[1] REDLINE REVISION 12/8/05

MD 202 AND ARENA DR/ LAKE ARBOR WAY

REVISION "G"

4985GI.dgn D6-66

WIRING DIAGRAM

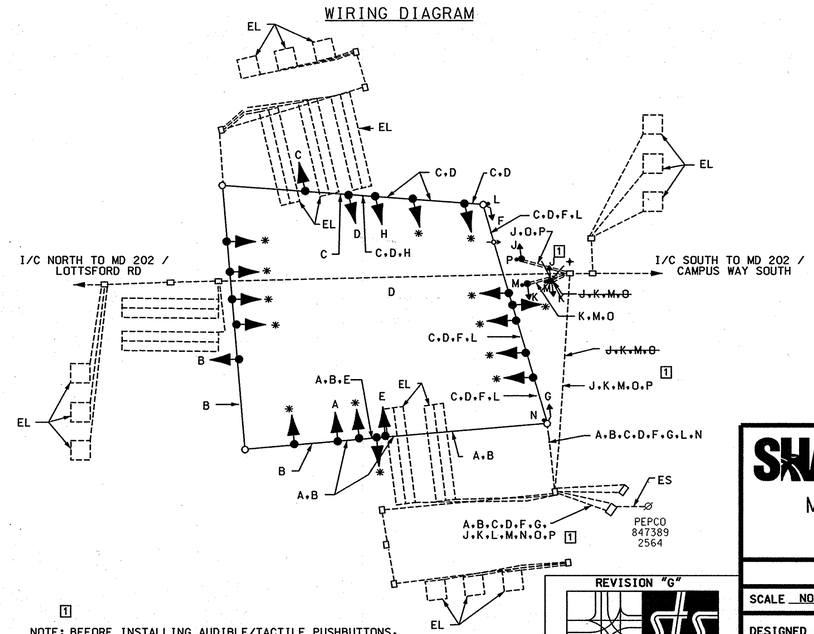
[1] NOTE: BEFORE INSTALLING AUDIBLE/TACTILE PUSHBUTTONS, THE CONTRACTOR SHALL DELIVER AUDIBLE/TACTILE PUSHBUTTONS TO SHA SIGNAL SHOP (MR ED RODENHIZER) FOR TESTING AND PROGRAMING.
